CITY OF KIRKLAND

NE 85TH ST PED-BIKE CONNECTION 114TH AVE NE TO 6TH ST JOB NO. 37-24-PW CIP No. STC1070000

ADDENDUM No. 1 **TO THE PLANS, SPECIFICATIONS, PROPOSAL AND CONTRACT**

Issued This Date: Friday, January 17, 2025
Bid Opening: **Unchanged – February 5, 2025**
Place of Opening: City Hall, Council Chambers

DWG. NO. DR1

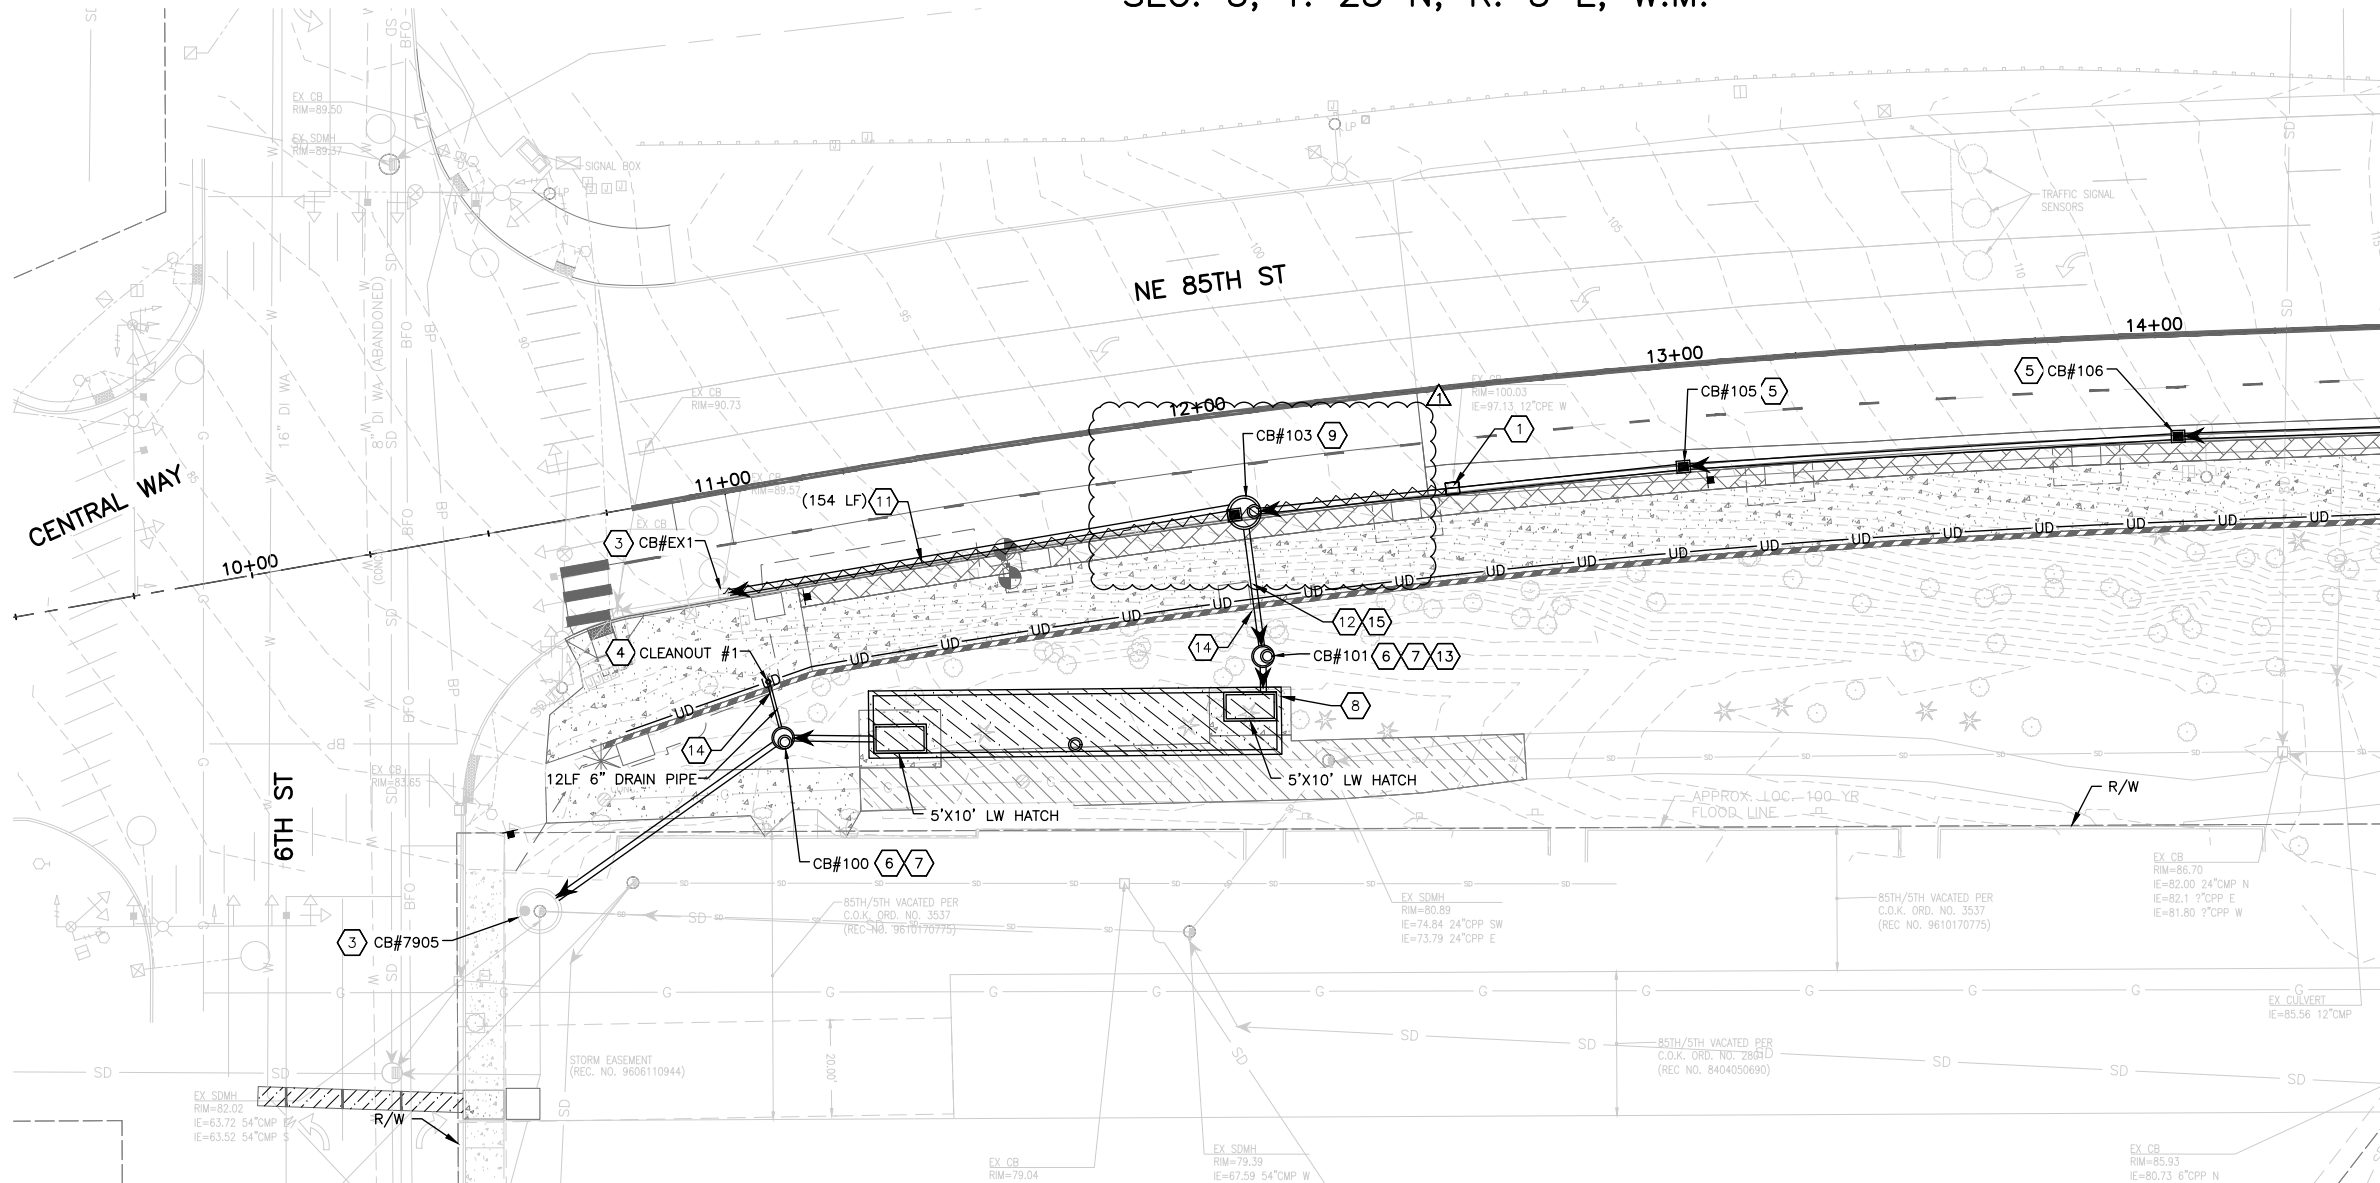
Description: Sheets DR1, DR2, DR3, DP1, DP3, DP4, DD1, DD2, WP1 - Replace in their entirety with the revised sheets, sheets 21-24, 26-29, 66 which are included as an attachment to this addendum

FILE	ENGR.	REVIEW	SCALE	DATE
DR1	##	##	AS SHOWN	JANUARY 2025
▲	DRAINAGE PLAN LAYOUT UPDATE		TWC	VWW 1/17/2025
NO.	REVISION	BY	REVIEW	DATE

DWG. NO. DR2

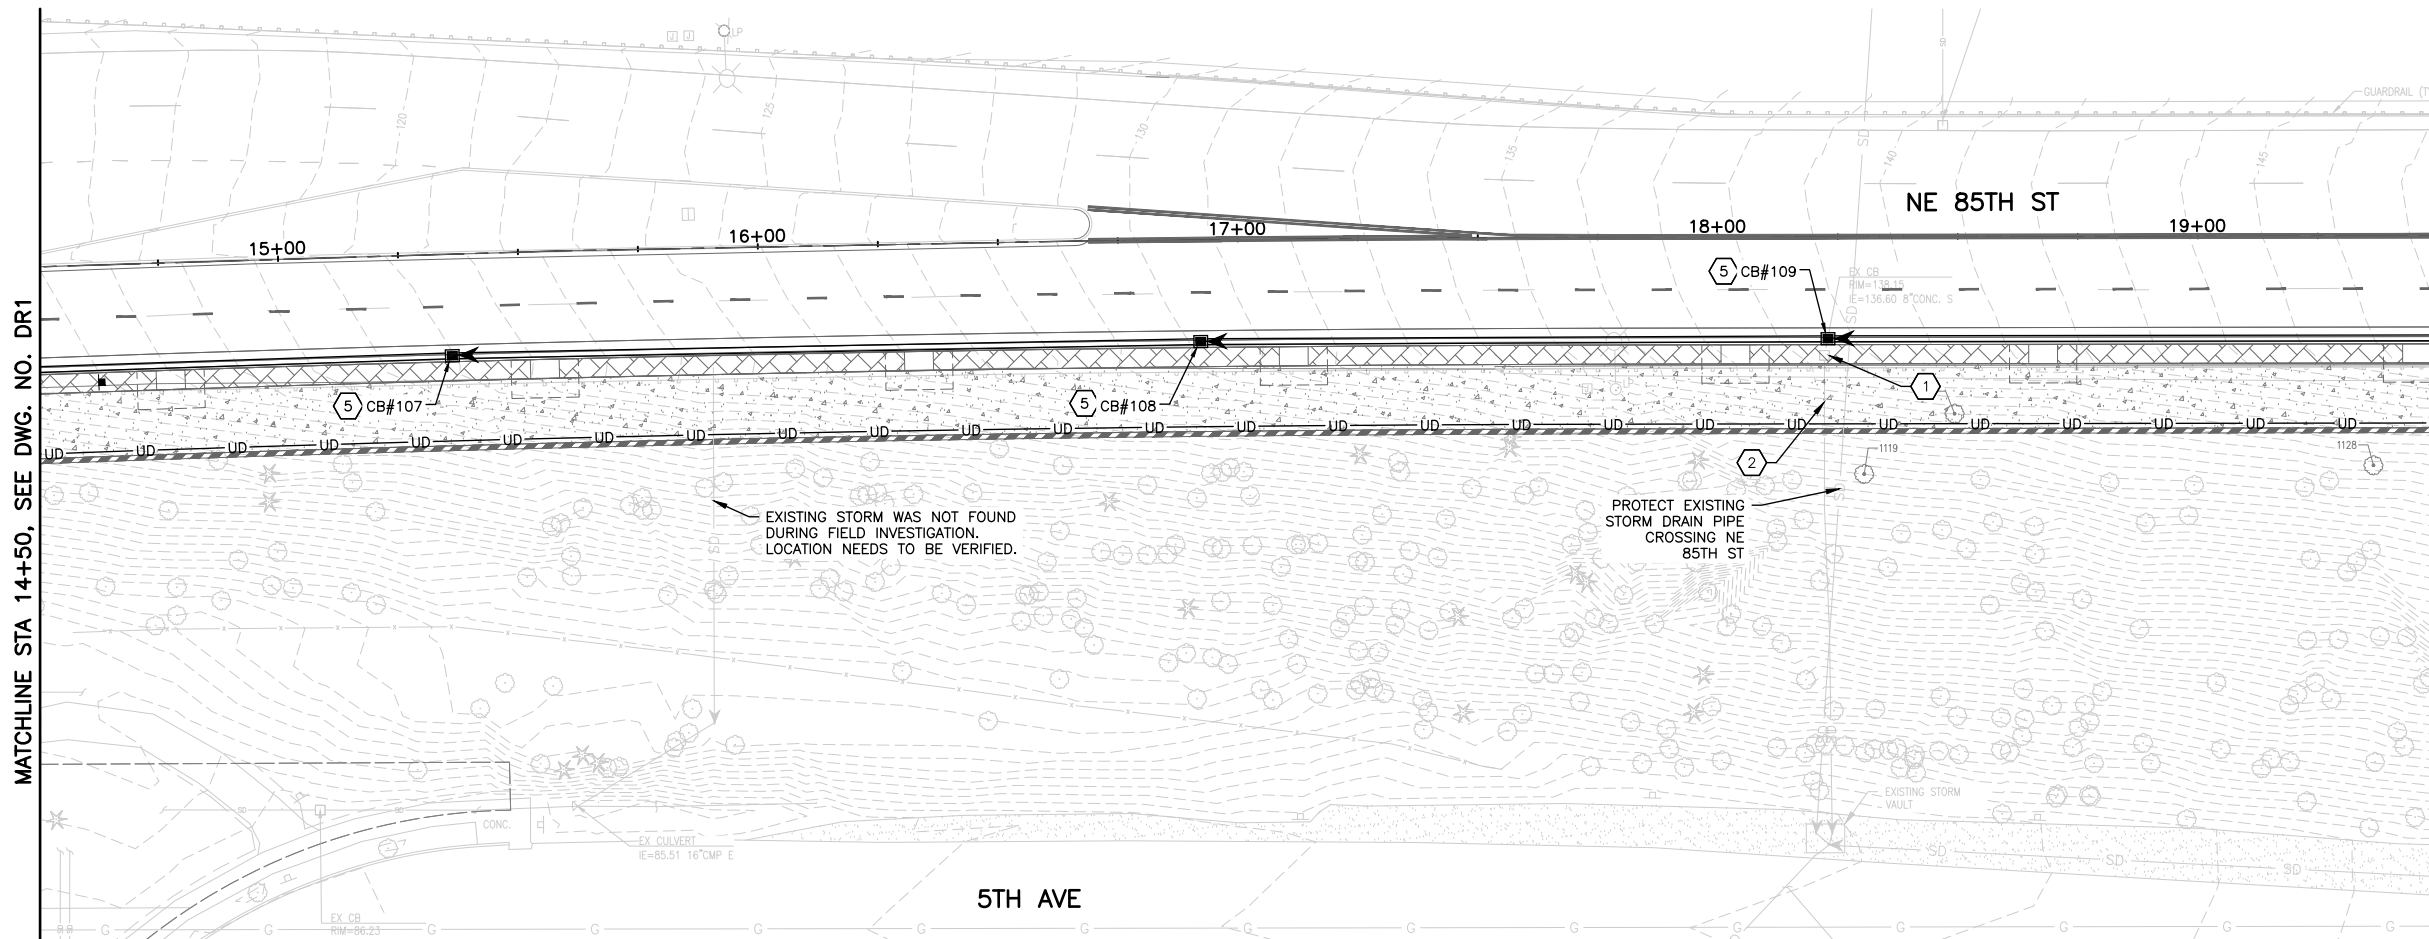
FILE	ENGR.	REVIEW	SCALE	DATE
DR2	##	##	AS SHOWN	JANUARY 2025
Δ	DRAINAGE PLAN LAYOUT UPDATE		TWC	VWW 1/17/2025
NO.	REVISION	BY	REVIEW	DATE

DWG. NO. DR3

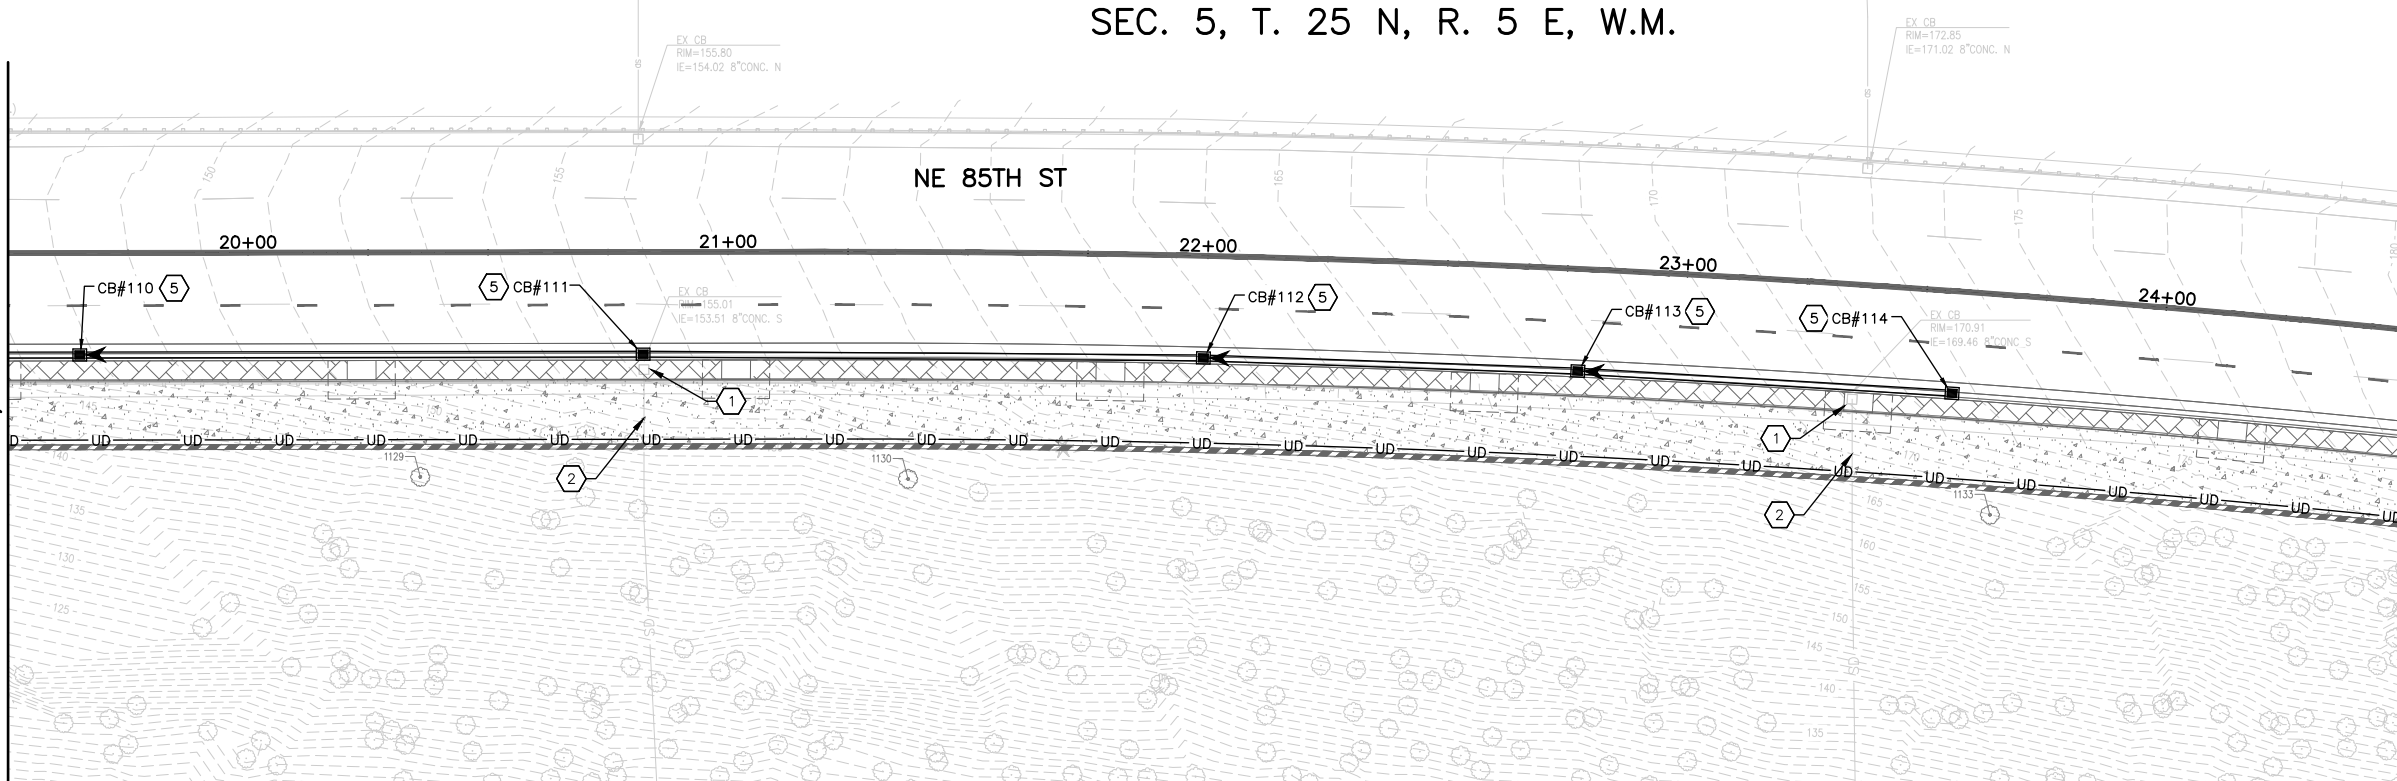
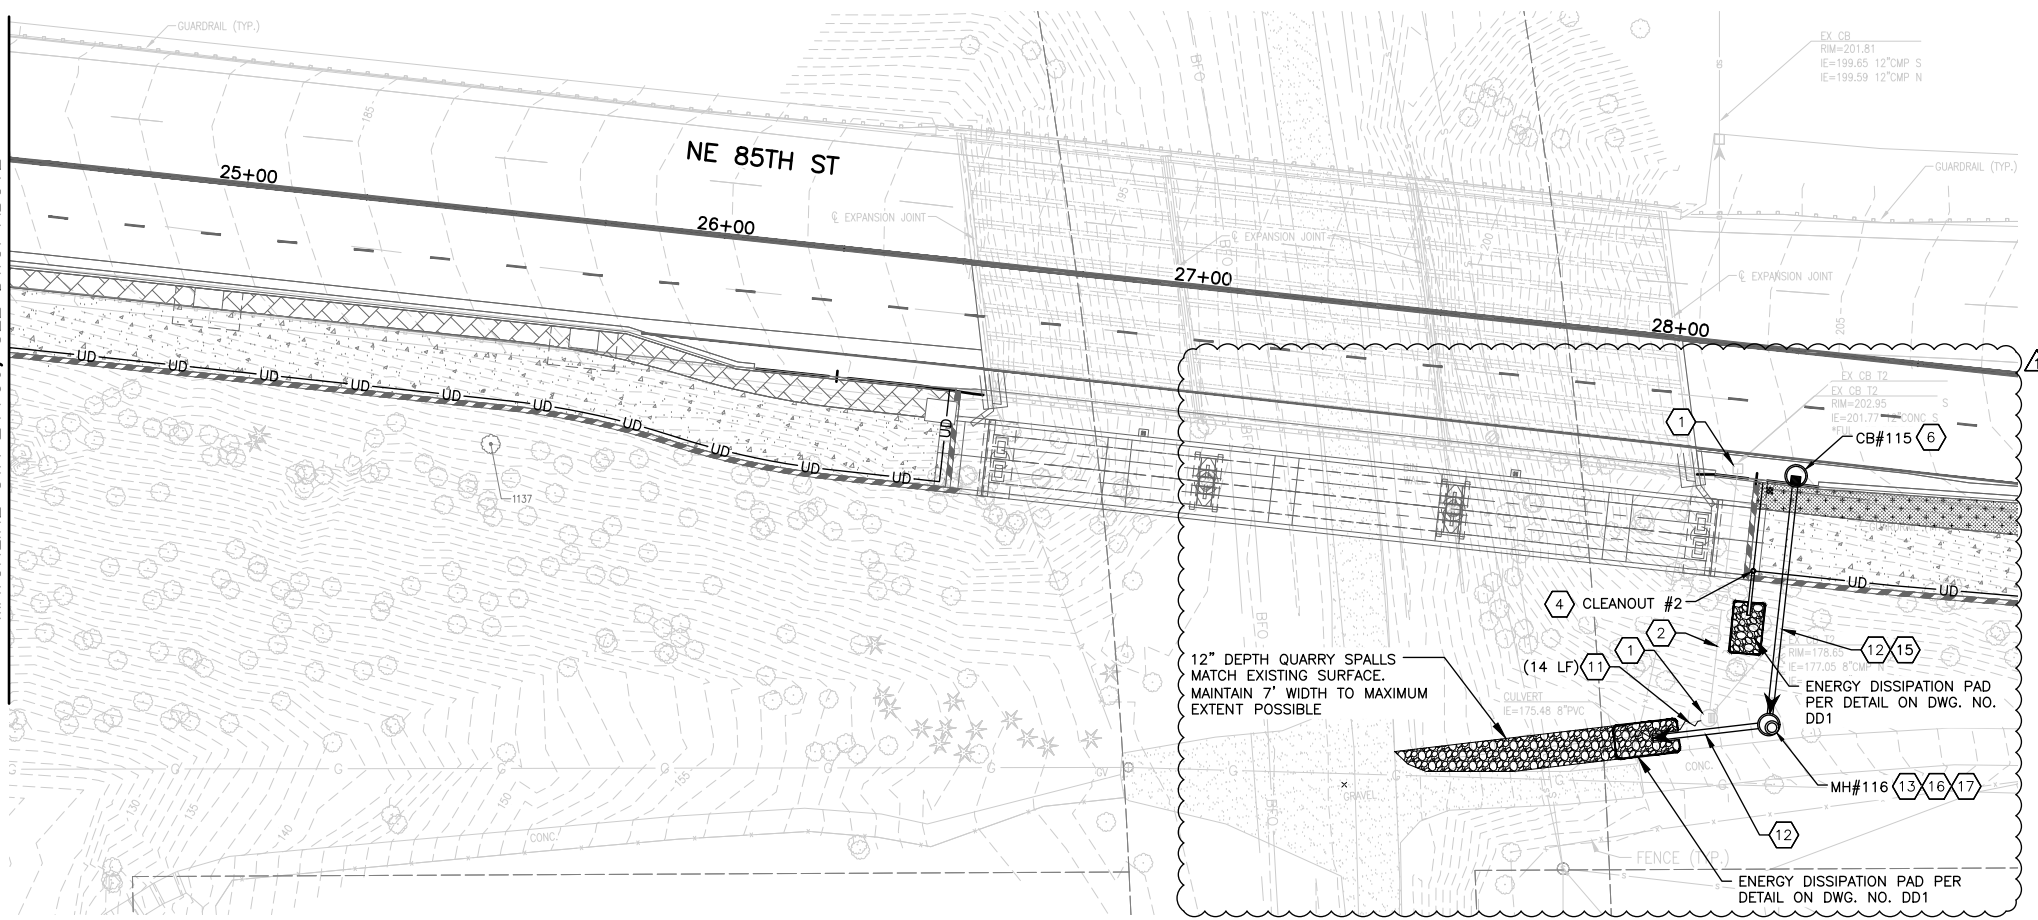
FILE	ENGR.	REVIEW	SCALE	DATE
DR3	##	##	AS SHOWN	JANUARY 2025
△	DRAINAGE PLAN LAYOUT UPDATE		TWC	VWW 1/17/2025
NO.	REVISION	BY	REVIEW	DATE

DWG. NO. DP1

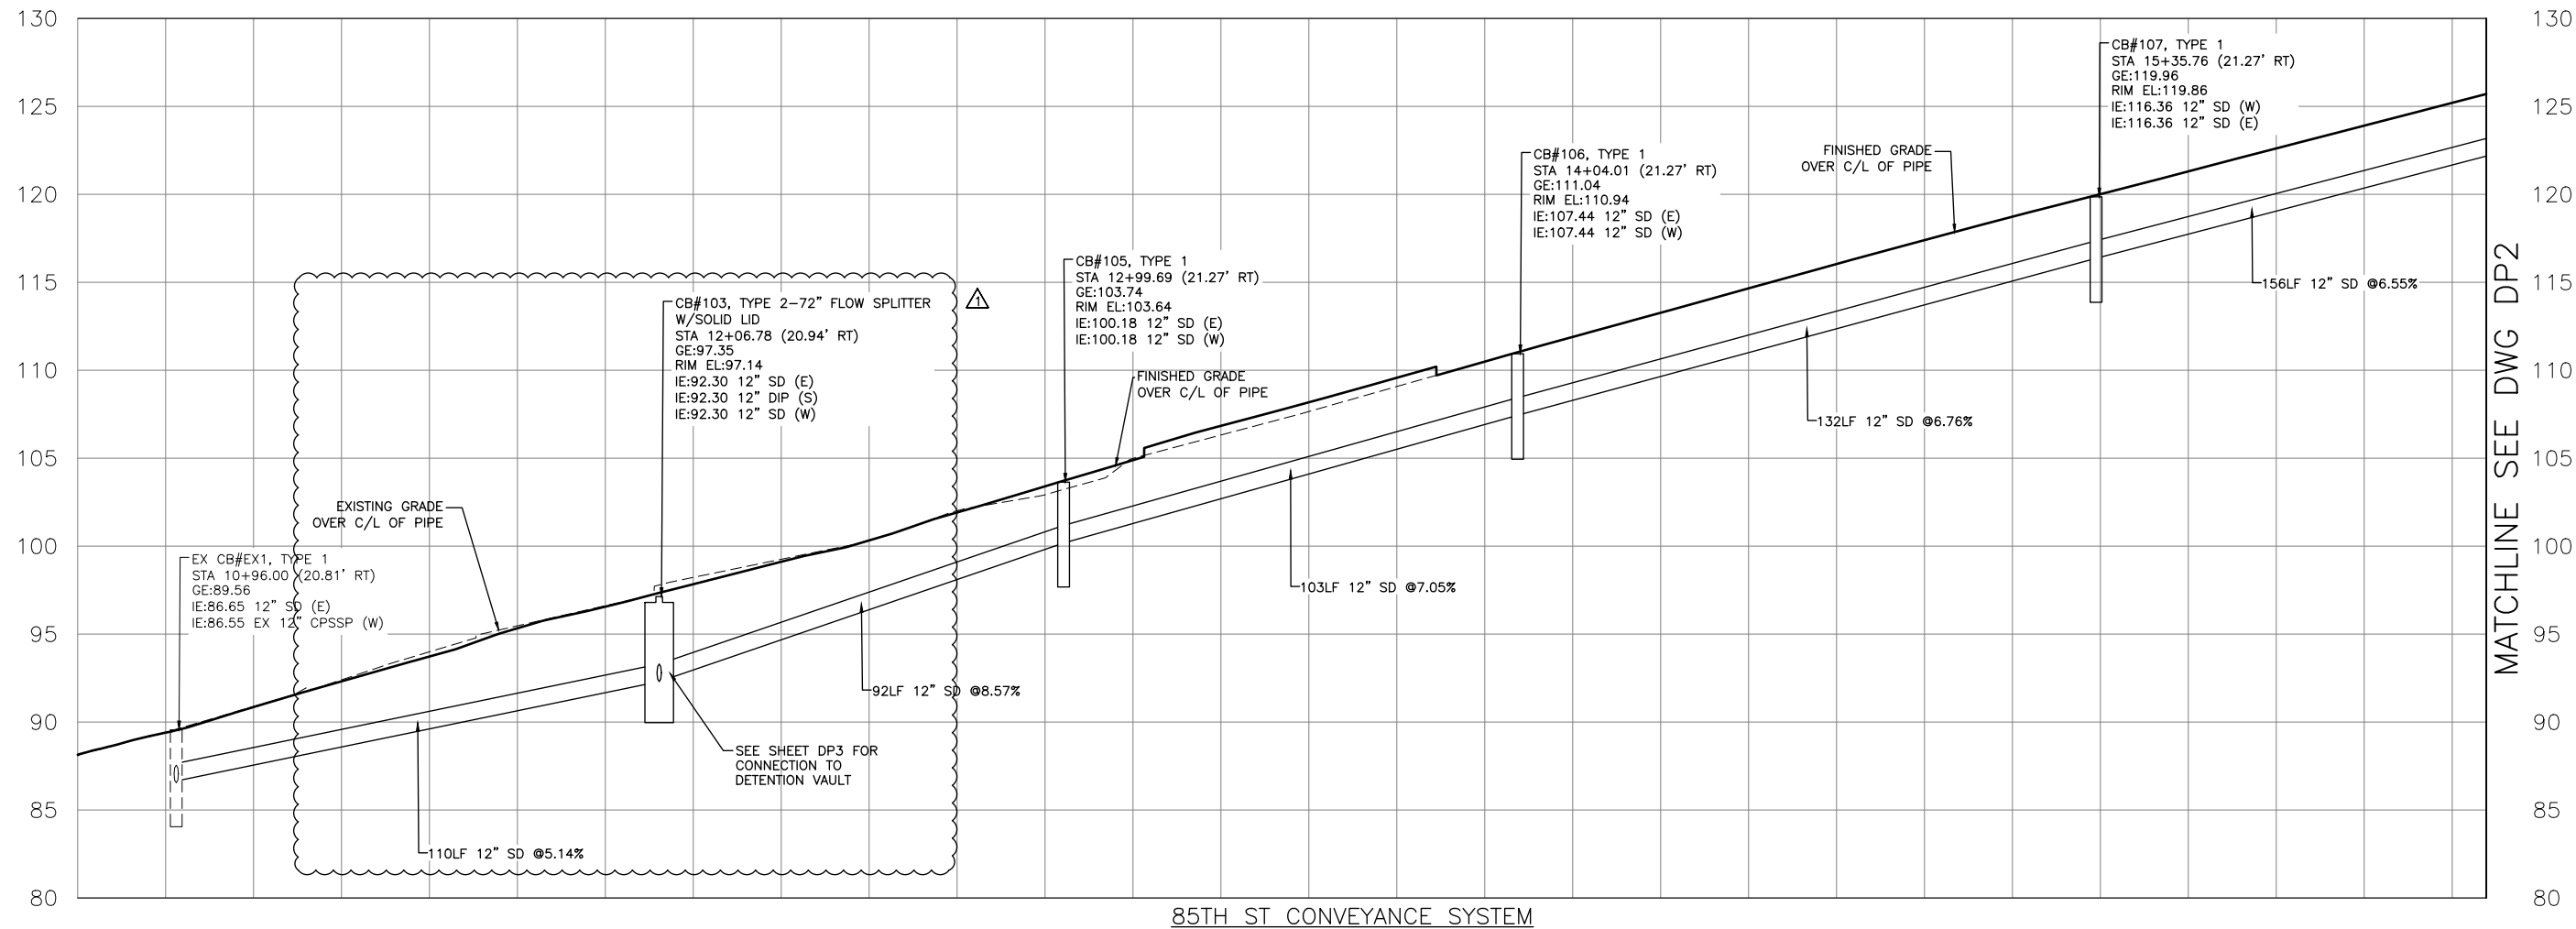
FILE	ENGR.	REVIEW	SCALE	DATE
DP1	##	##	AS SHOWN	JANUARY 2025
△	DRAINAGE PROFILE UPDATE		TWC	VWW 1/17/2025
NO.	REVISION	BY	REVIEW	DATE
